ADMINISTRATIVE OFFICE OF THE COURTS

QUESTIONS AND ANSWERS

RFP Number: RFP# CJER 05-13-RB

AV VIDEO SYSTEMS MODIFICATION AND INTEGRATION SERVICES

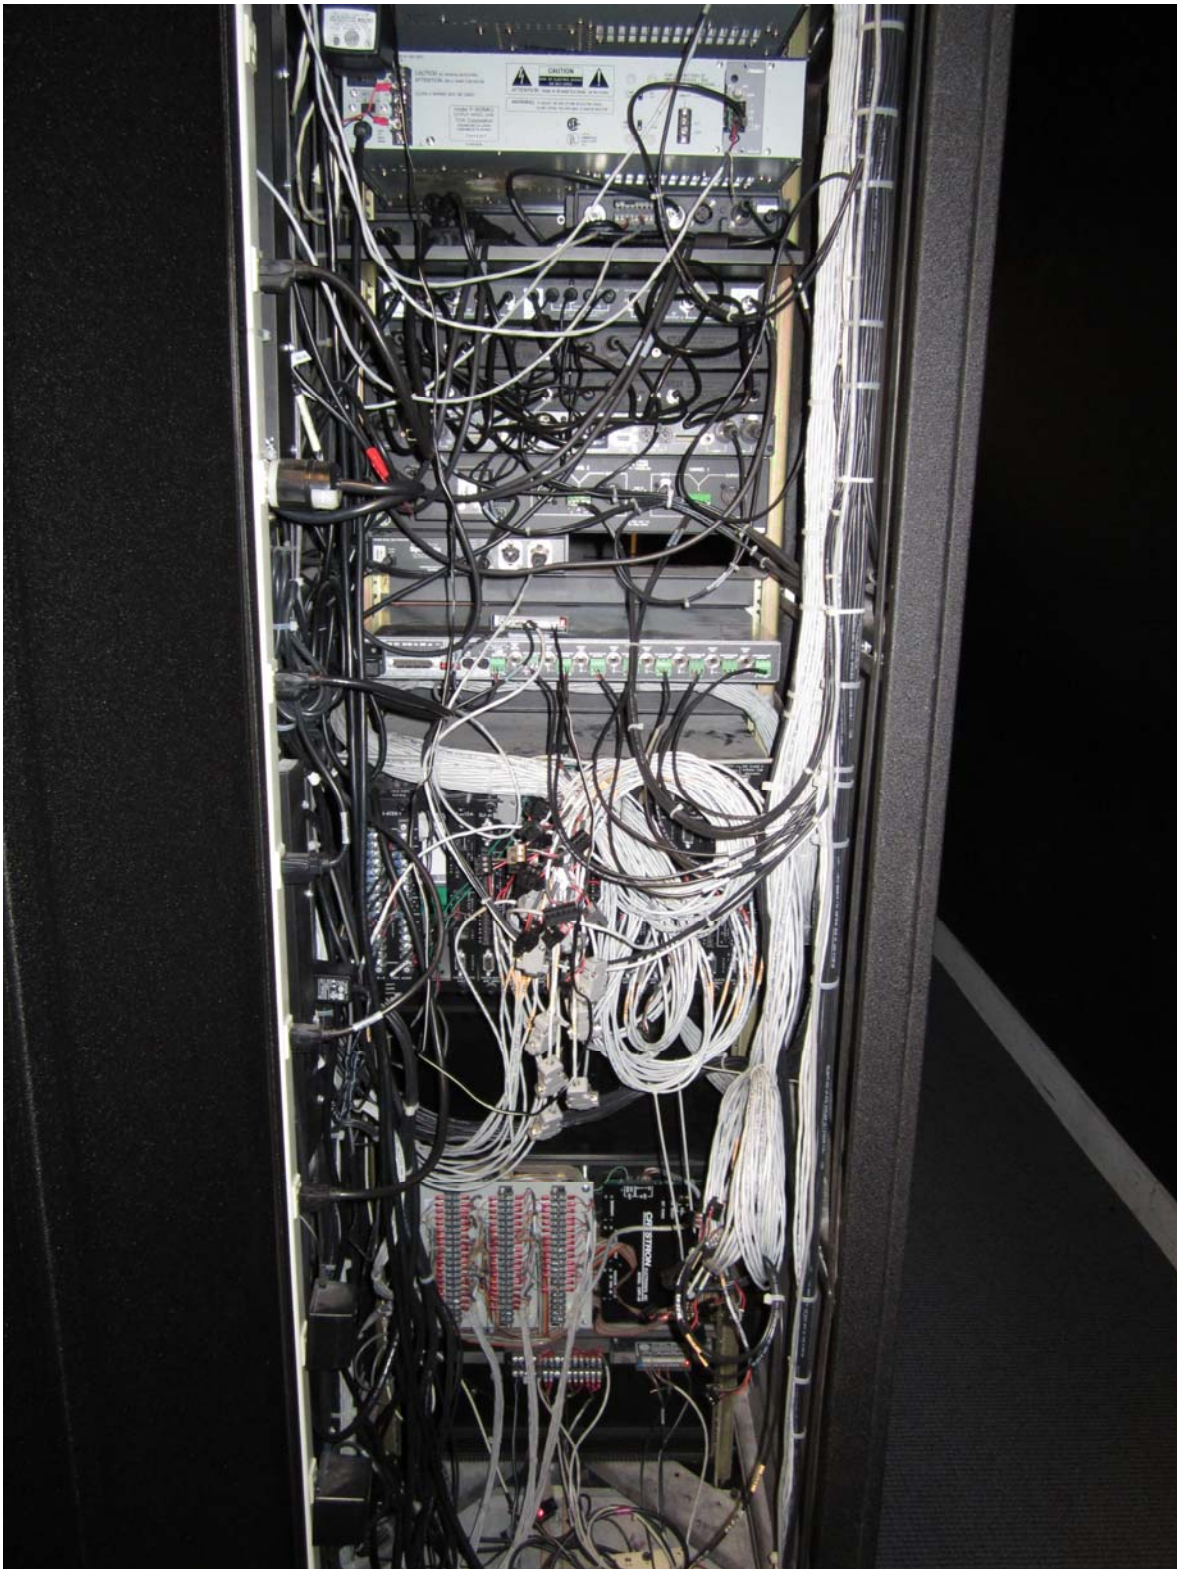
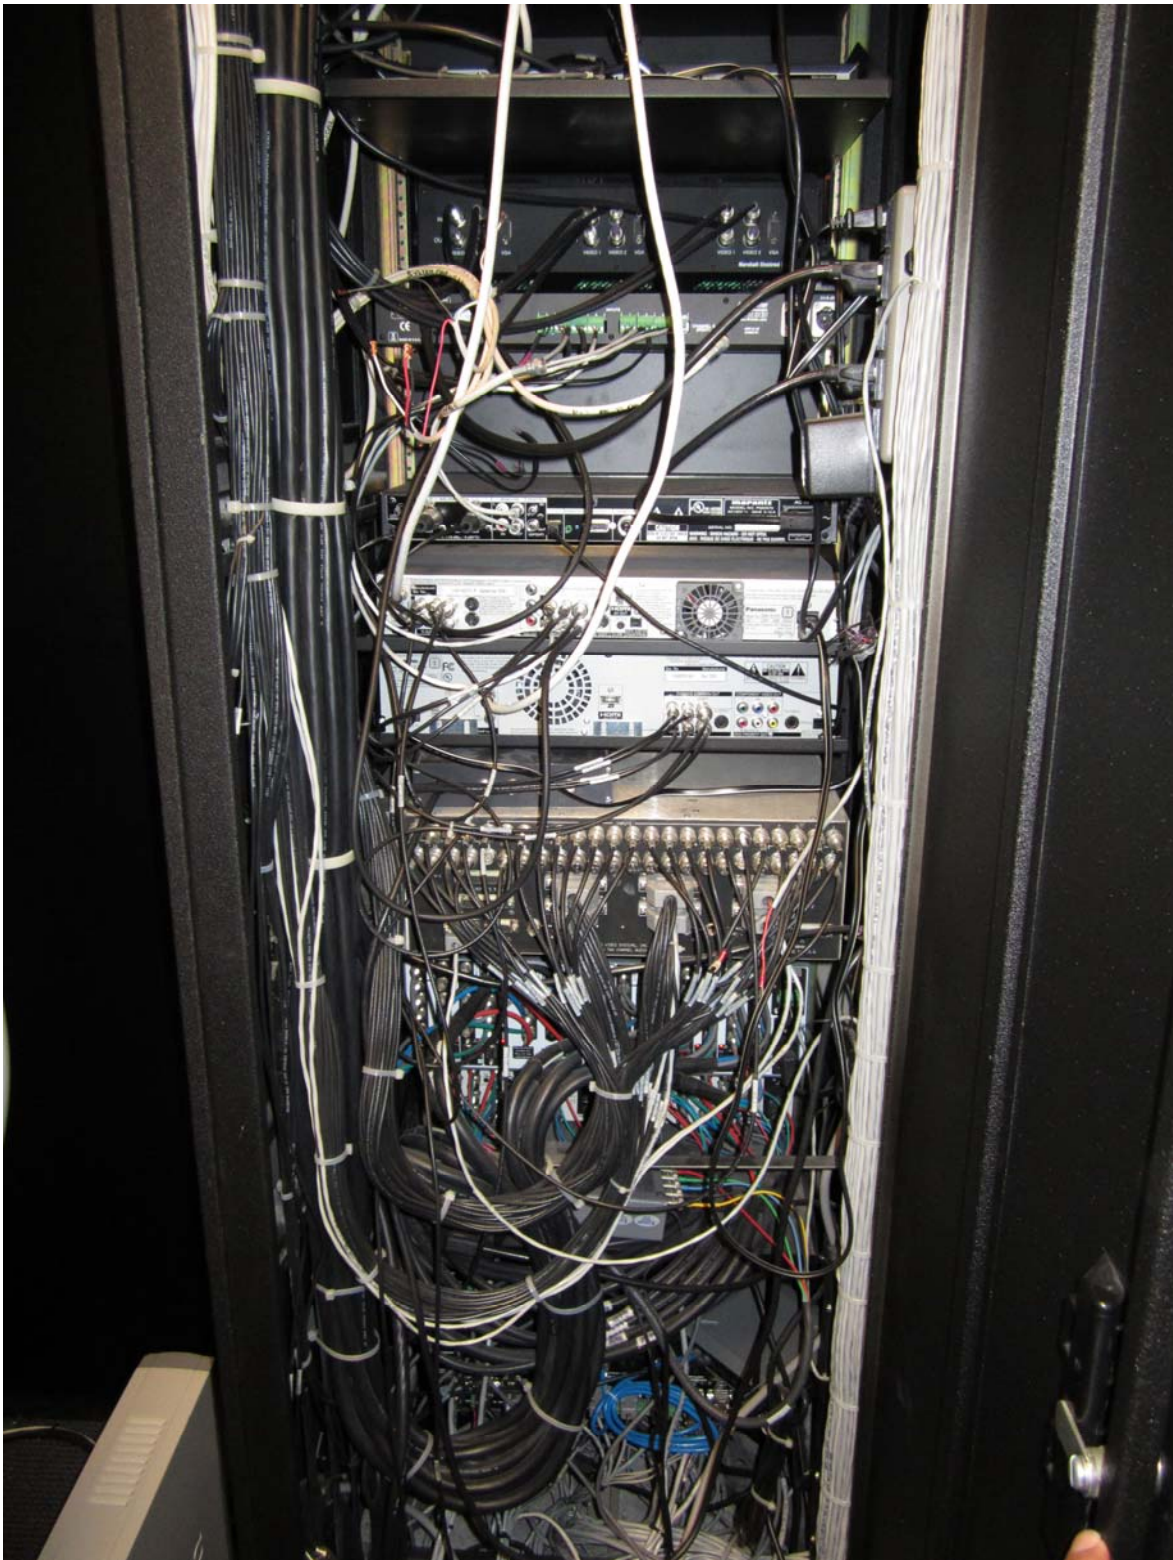
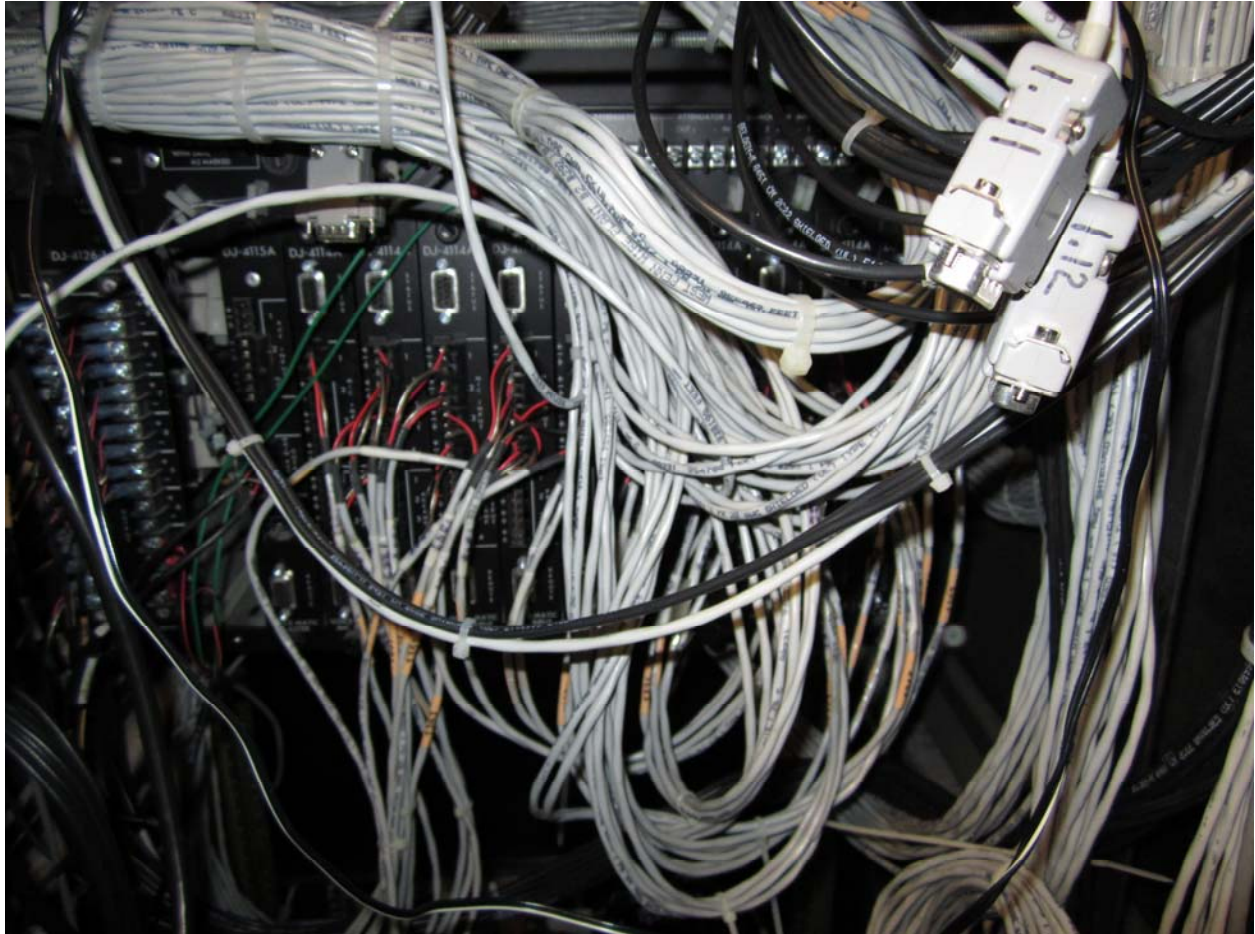
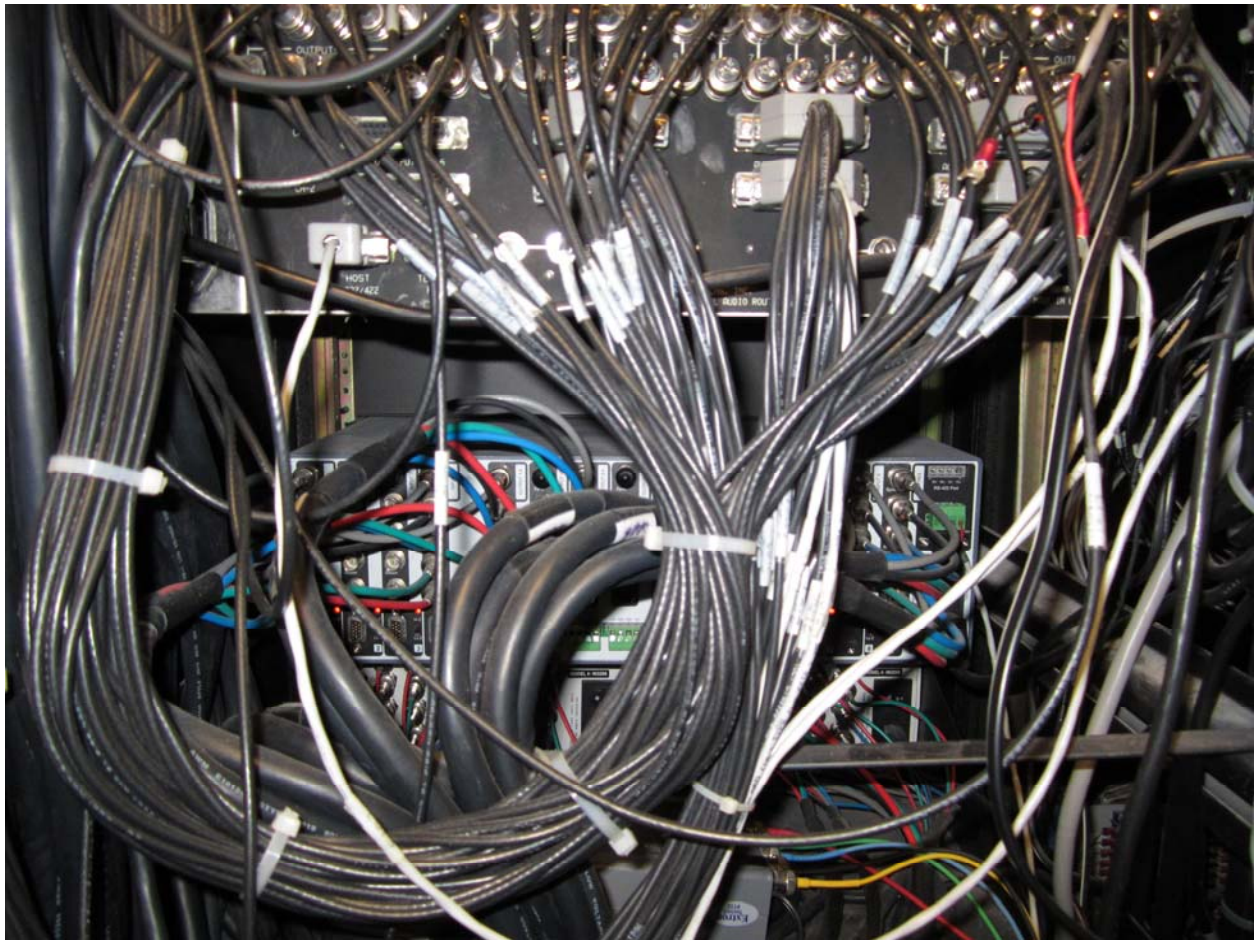
26. Can you provide pictures of racks in the Judicial Council Boardroom?

ANSWER: Yes, please see the following 7 pictures.
